Decision Date: January 31, 2019

Vesting Tentative Tract No. 75010-SL
Related Case: DIR-2017-2631-SPP
Address: 11857 Riverside Drive
Plan Area: North Hollywood – Valley Village
Specific Plan: Valley Village
Zone: [Q]RD1.5 and R1-1
D.M.: 168-B-169
C.D.: 2
CEQA: ENV-2017-2629-CE
Legal: Lot 295 and FR 296 (Arb 1); Tract 8627

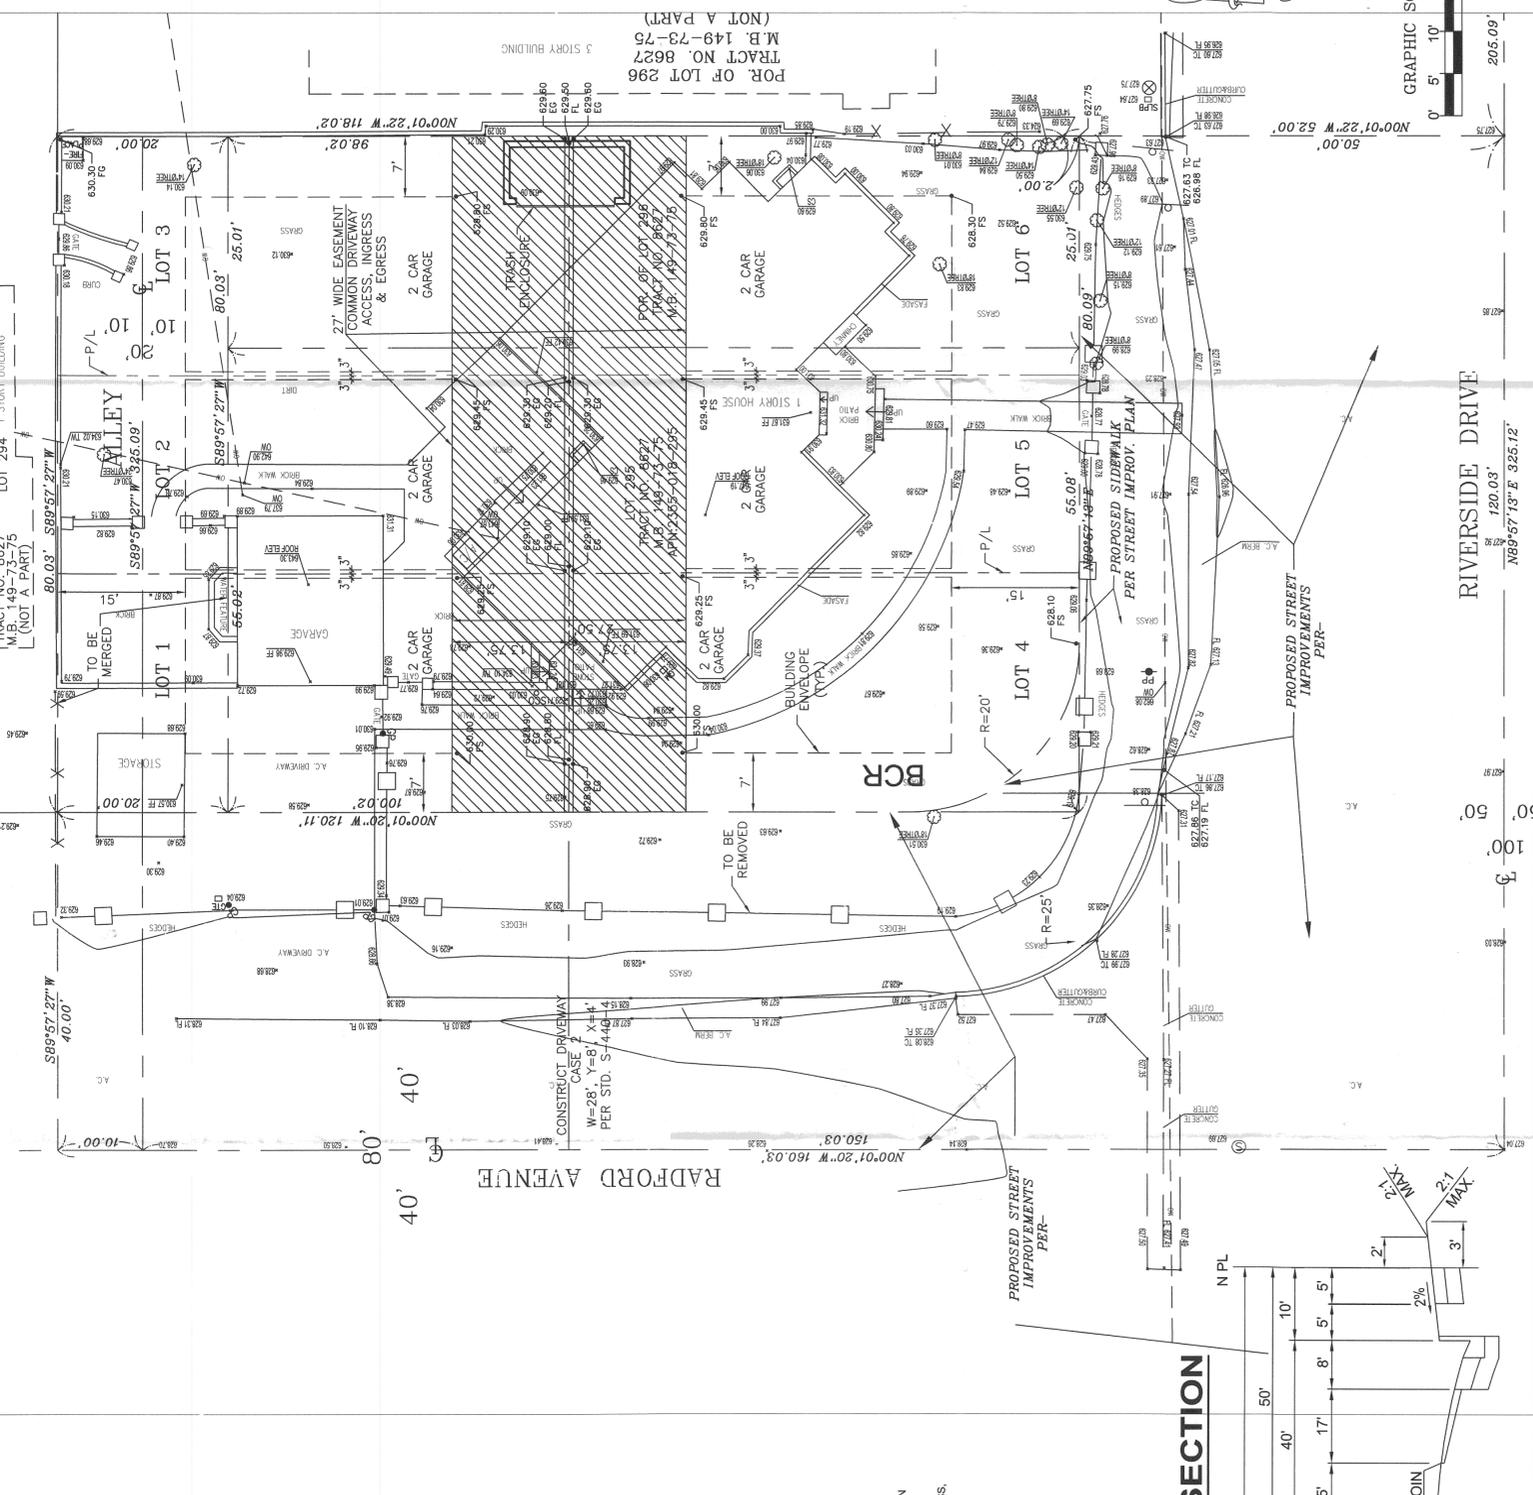
- b. The submitted Map dimensions do not agree with ZIMAS. Revise the Map to address the discrepancy or obtain approval from Department of City Planning. (See Condition No. 29b).

- e. Lot 1 along Riverside Drive and Lot 6 along Radford Avenue do not comply with the minimum 15 ft. front yard setback after required street dedication is taken as required for the [Q]RD1.5-1 Zone. Revise the Map to show compliance with the above requirement or obtain approval from the Department of City Planning for the setbacks indicated in the Setback Matrix.
- f. Revise the proposed Lot Matrix to reflect the correct orientation and setbacks per the proposed map.
- g. A 5-foot side/rear yard setback is required for the small lots adjacent to the lots not part of the tract. Revise the map or obtain City Planning approval to have the Setback Matrix reflect the correct setbacks shown on the map.
